## TECHNICAL BULLETIN

V6 Engine MIL Lamp On/DTC P0332 –  
Water Entry In Knock Sensor Connector –  
Install Sealing Patch

MODEL 2003-04 MY  
S-TYPE 3.0L  
VIN M44998-N13088

Remove and destroy Bulletin S303-24, dated 03/05.  
Replace with this Bulletin.  
Revisions are marked with a bar and in **bold text**.

ILLUSTRATION 1

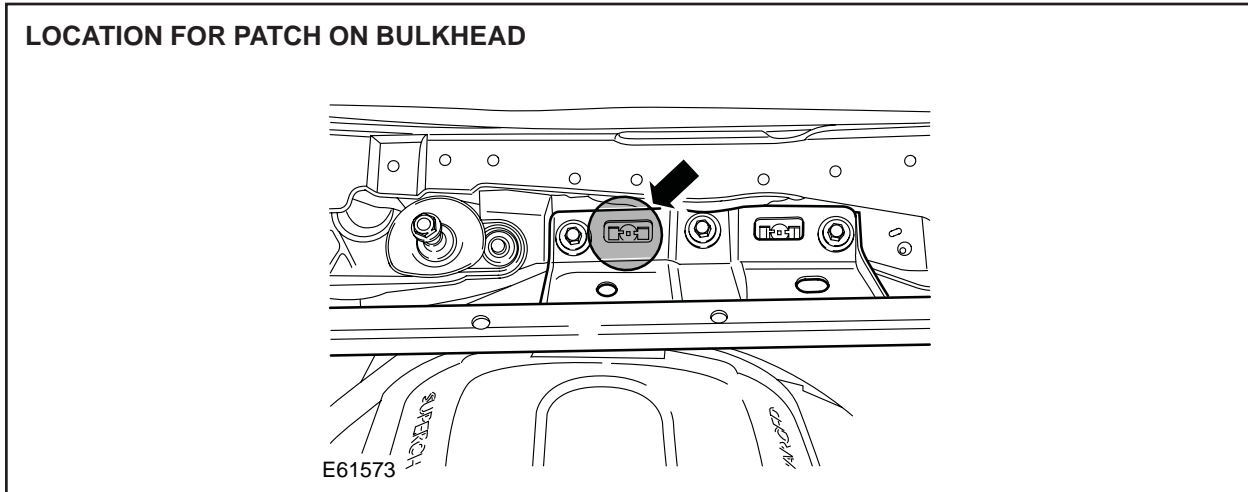
5. Switch 'OFF' PTU, disconnect from vehicle and return WDS to original location.
6. Remove the cowl panel grille (see Global Technical Reference GTR Workshop Manual, section 501-02).
7. Clean the area on the bulkhead bracket of the suspension turret brace where the adhesive patch will be applied (Illustration 1).

8. Ensure the plastic insert is centered in the rectangular hole of the brace.
9. Remove and discard the backing from the adhesive patch and install the patch centered over right-hand rectangular hole furthest to the rear the brace (see illustration 1).
10. Install the cowl panel grille (see Global Technical Reference GTR Workshop Manual, section 501-02).
11. Remove the **left-hand** (upper) knock sensor (see Global Technical Reference GTR Workshop Manual, section 303-14A, SRO 18.30.92).
12. Remove the engine harness electrical connector for the knock sensor from the mounting, and position it downwards to ensure no water is present in the PVC tube that covers the harness.

ILLUSTRATION 3

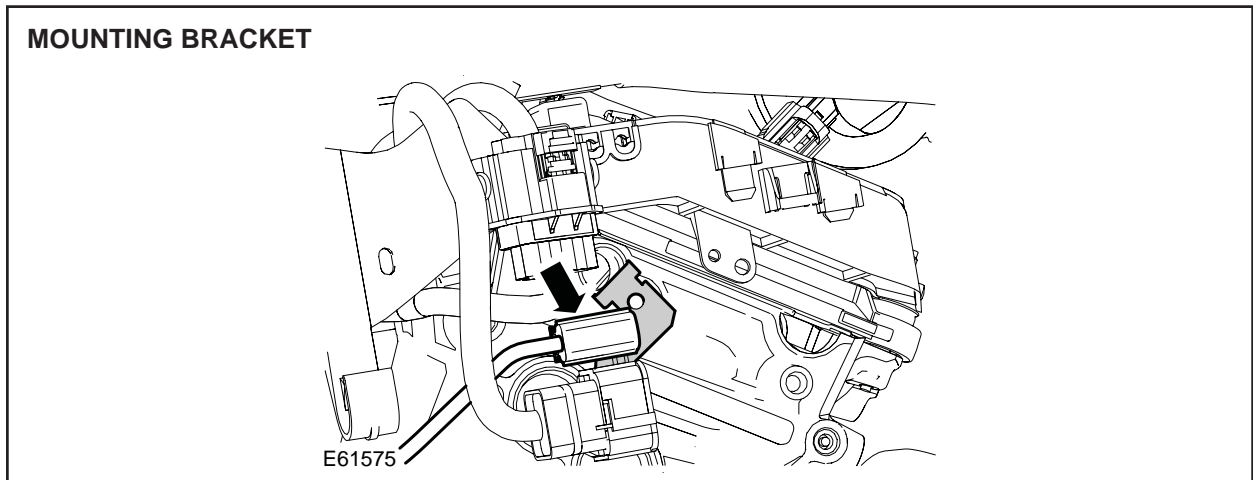
13. Install the engine harness electrical connector for the knock sensor in the new mounting position (Illustration 3).
